RFP Title: Providence City Hall Elevator Replacement

Addendum #: 3

City Hall Elevator Replacement Addendum 3

Bidder Questions

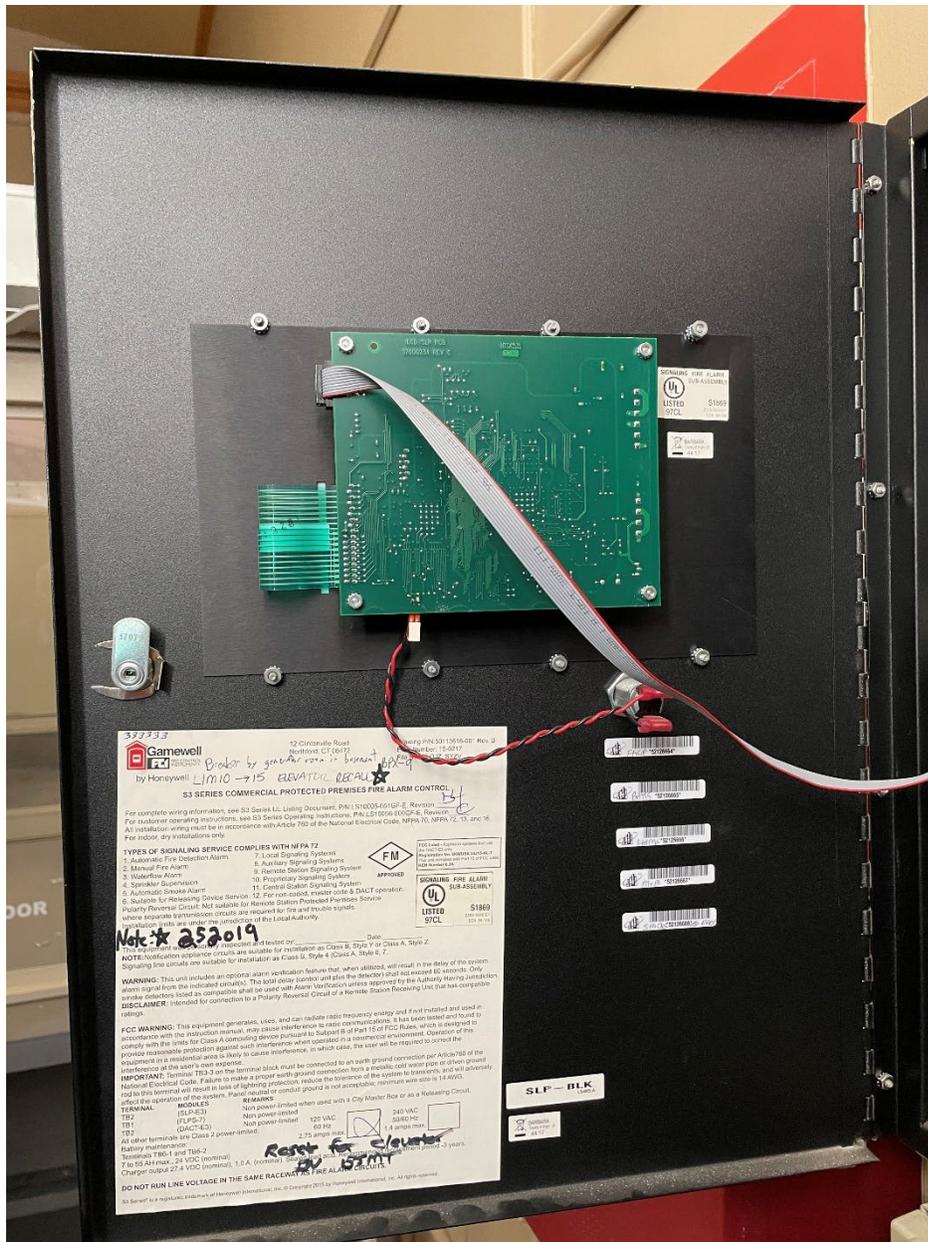
- 3) What is the location and make and model of the fire alarm control panel ?
 - a. The fire alarm control panel is located next to the rear handicapped entrance to the building on the Eddy St side. It is a Honeywell panel, photos shown below.
